MEMORANDUM

DATE: JANUARY 27, 2021
TO: COASTAL PERMIT ADMINISTRATOR
FROM: JULIA KROG, ASSISTANT DIRECTOR
SUBJECT: CDPM_2020-0002 (SCHAFFER) – MODIFICATION TO STAFF REPORT, CONDITIONS, AND ADDITION OF GEOTECHNICAL REPORT AS PART OF THE RECORD

**PROPOSED SCHAFFER RESIDENCE,
FAMILY CARE UNIT AND DRIVEWAY
3890 NORTH HIGHWAY 1
ALBION, CALIFORNIA**

Attachment B to Memorandum

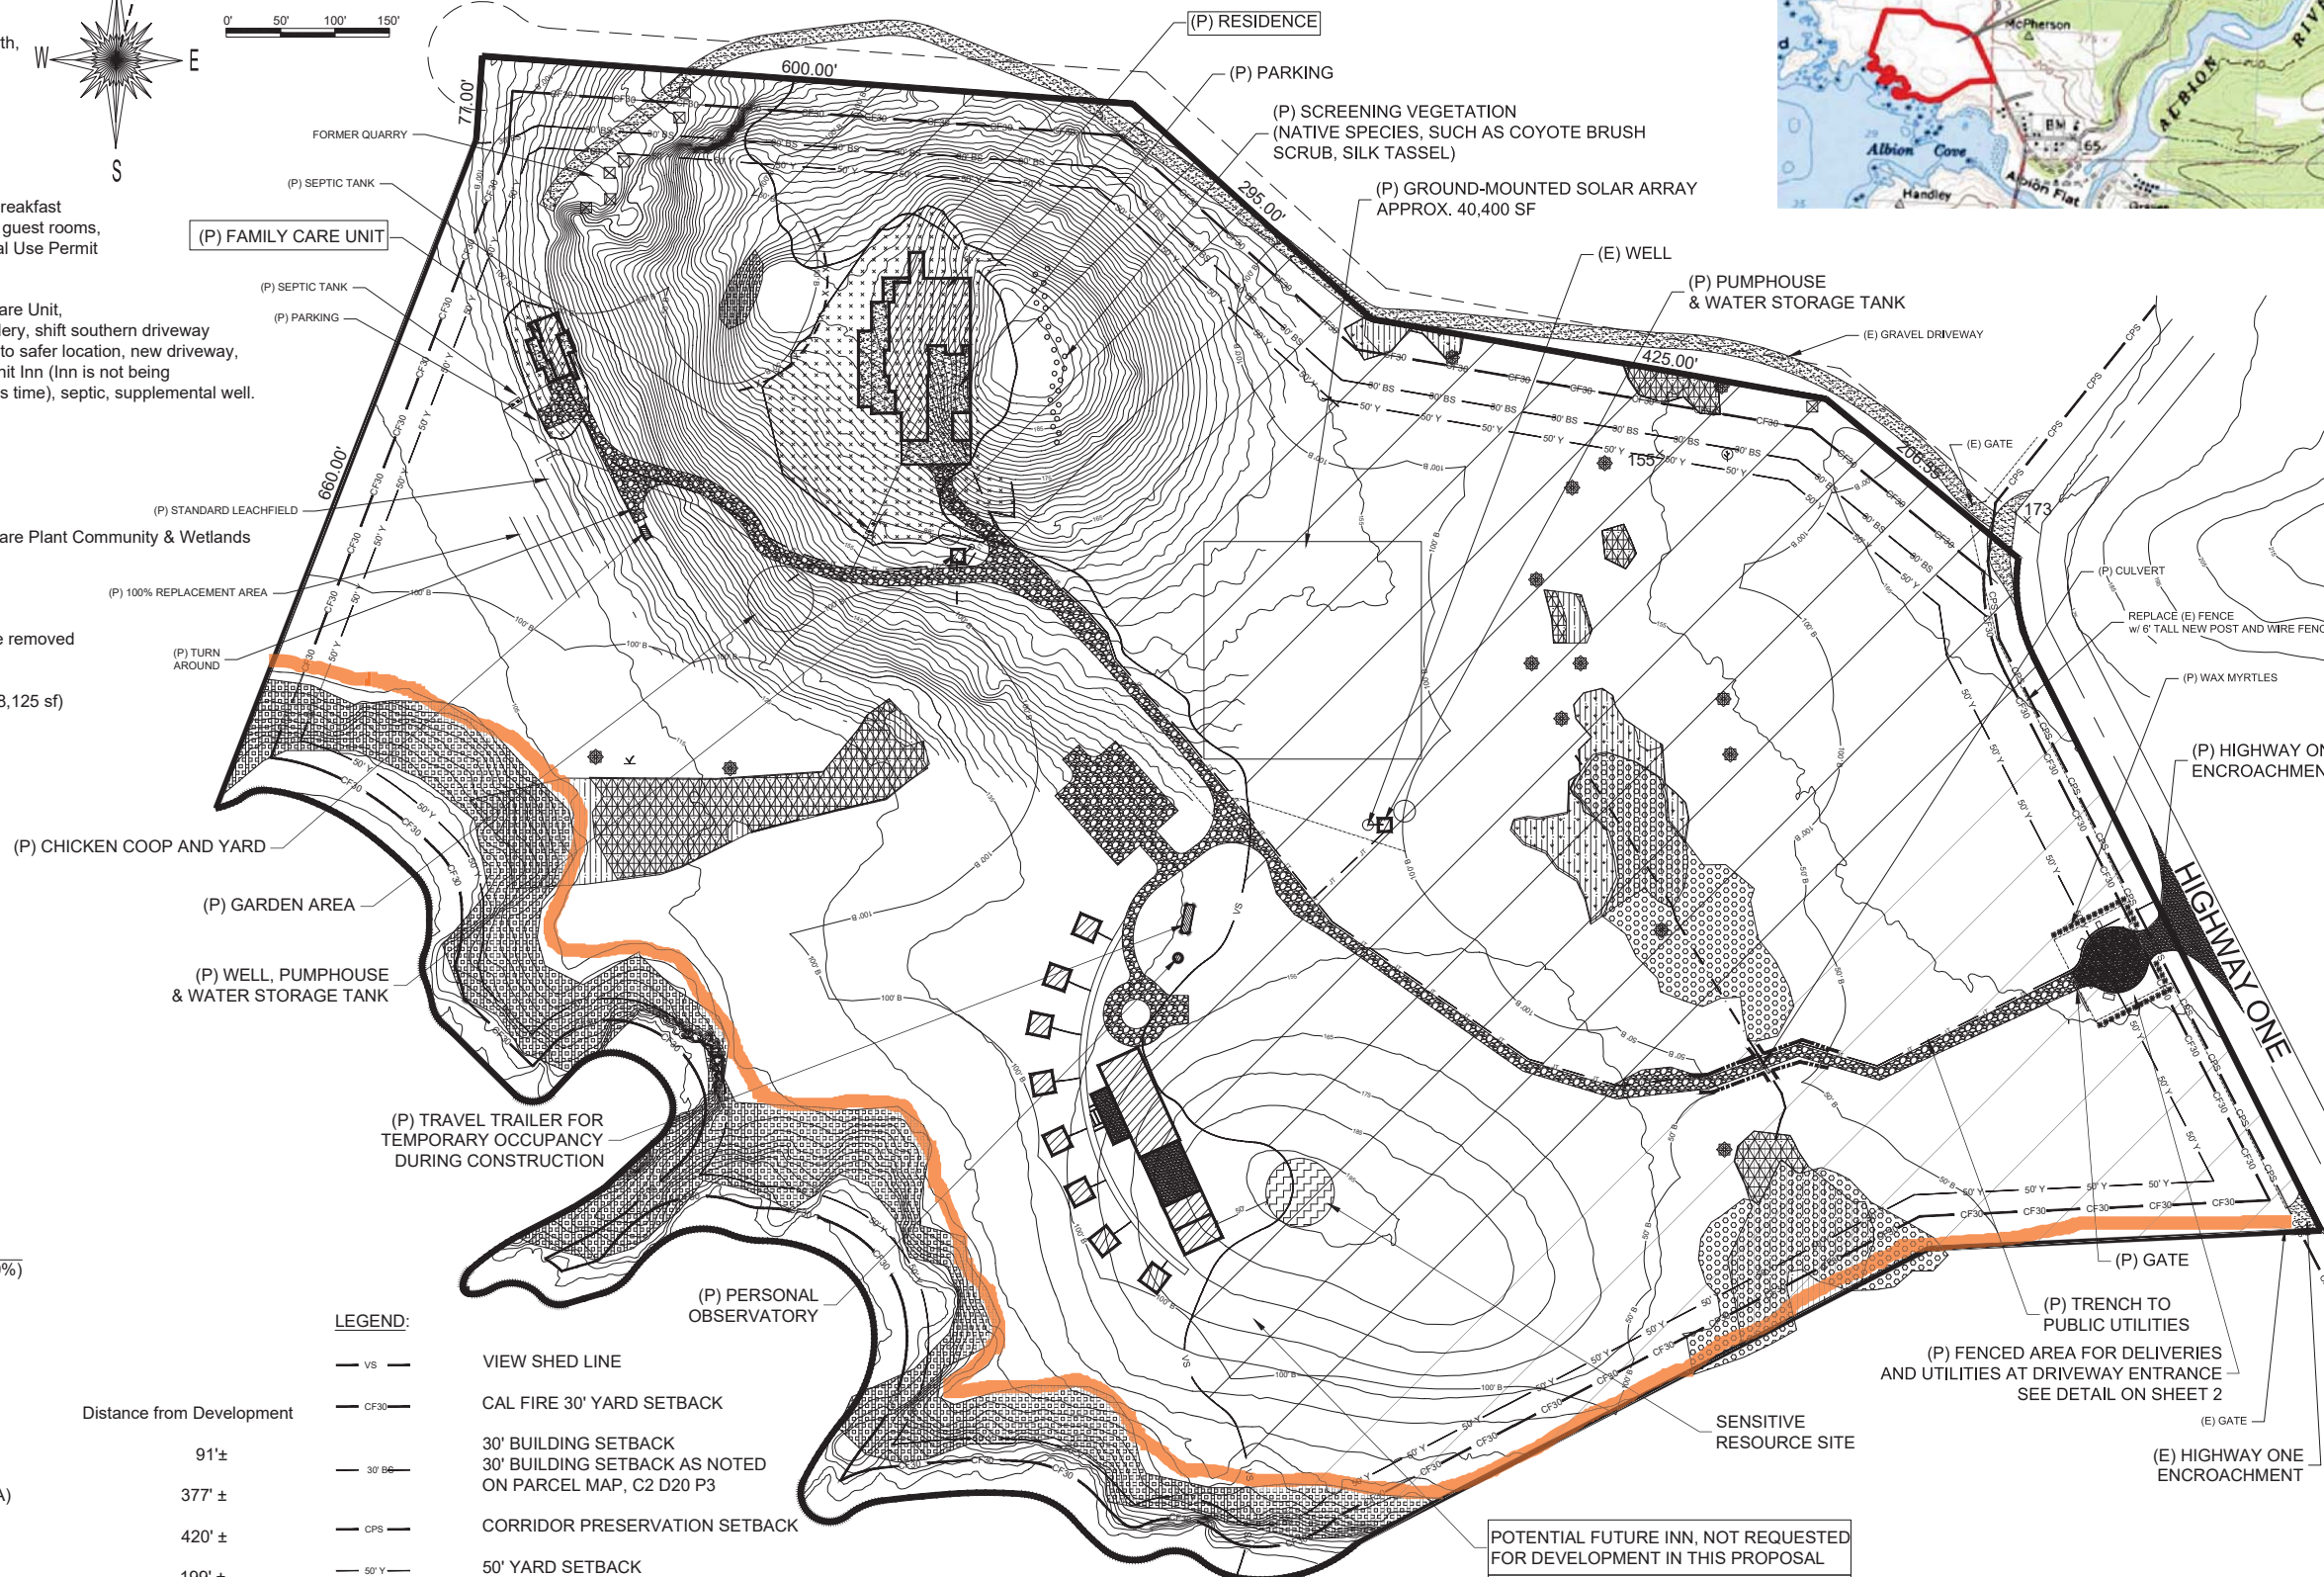
Corrected Exhibits: After distribution of the Staff Report, the Agent for the project noticed several inconsistencies in the Site Plan provided in the Staff Report (Attachments D and E of the Staff Report). These inconsistencies included the Guest Cottage label where it is meant to read Family Care Unit and the correct road approach as was approved under CDP_2018-0018 and MS_2018-0004.

The Floorplans and Elevations for the proposed project on all structures has not changed from the originally approved project, CDP_2018-0018. The wrong exhibits were attached to this staff report and therefore corrected Attachments D through E are attached to this memorandum.
